P/51/11.

From: lilleyarchitecture [REDACTED]
Sent: 05 January 2012 11:26
To: Katherine Rawlins
Subject: RE: P/51/11 Extension, alteration and new detached garage 7 Webb Close Pagham
Attachments: 185 PL01rev01.pdf; 185 PL04rev01.pdf; 185 PL05rev01 A.pdf

Proposed two
storey extension
Balcony to west side of
extension

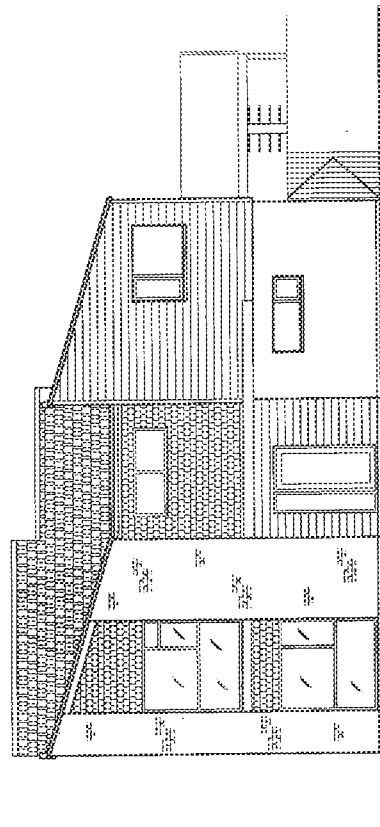
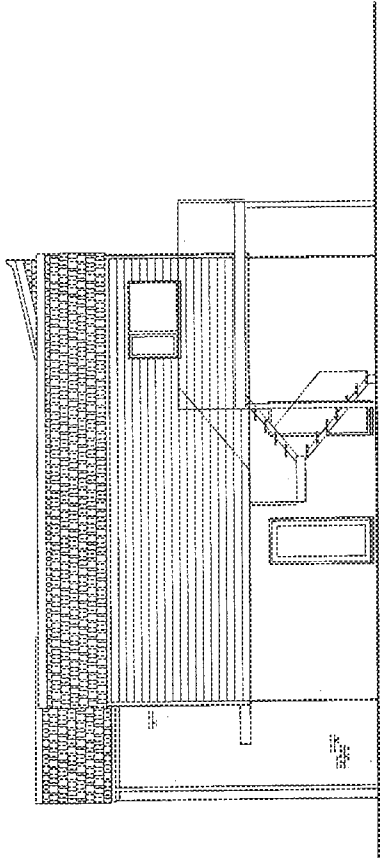
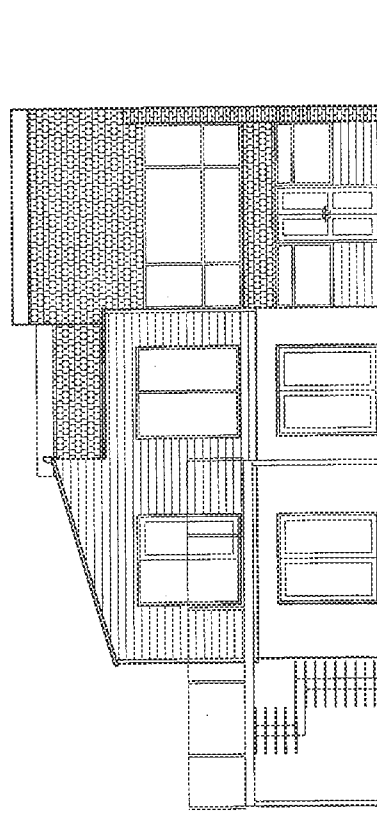
The roof line of the extension has also been altered to echo the rhythm of the roofs along the terrace more strongly. I hope you concur this resolves the extension quite neatly.

Ground floor

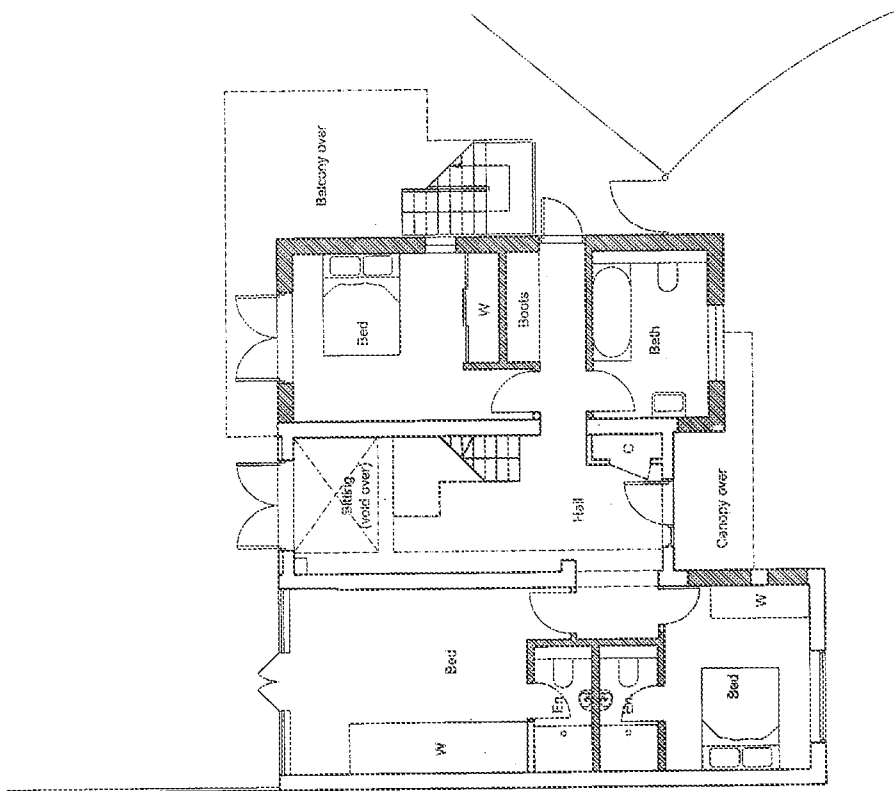
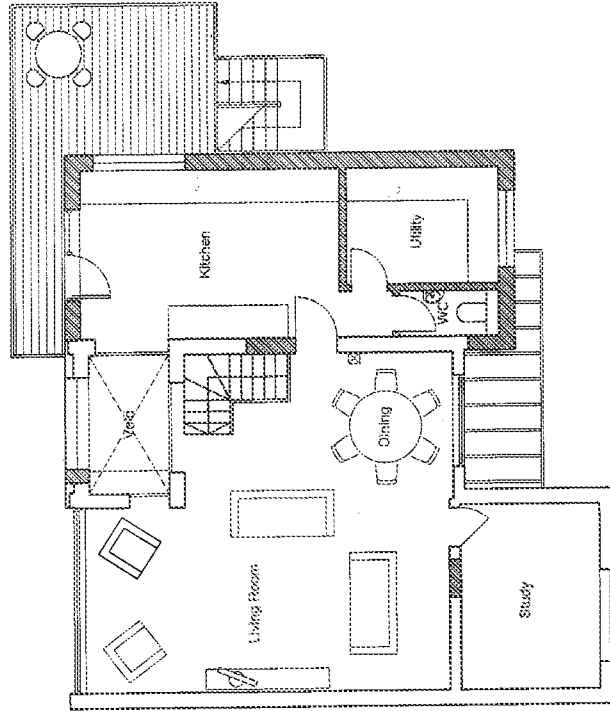
As discussed with Mr Parsons previously (see email thread below) I have rearranged the balcony in order to significantly reduce its rear projection. It now only projects 1m in order to allow access to the balcony now positioned to the side of the property.
